Product Update

Title: Update firmware for the PX

No: 200710-01

Summary: PX firmware was recently updated to include product operation enhancements.

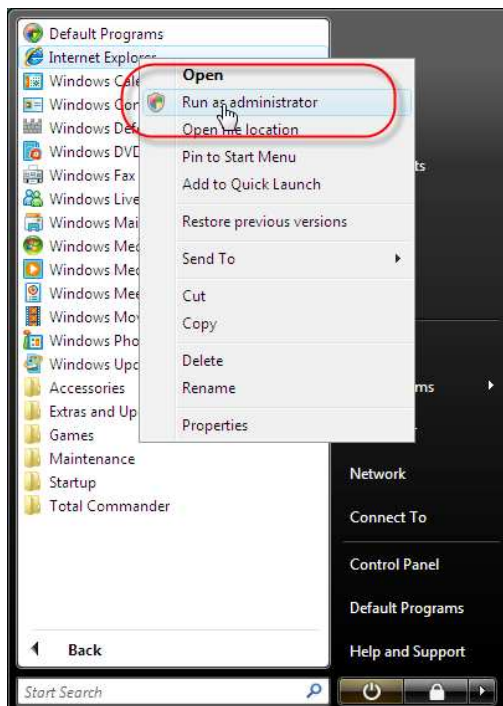
- Added support for Microsoft Windows Vista on a client computer:

To connect to the Smart IP Access from Windows Vista, the user must run the Internet Explorer as Administrator. To do this you need to right click on the explorer icon on the task bar and select to run the Internet Explorer application as administrator.

Look at the image below: (note: type the administrator's password when prompted)
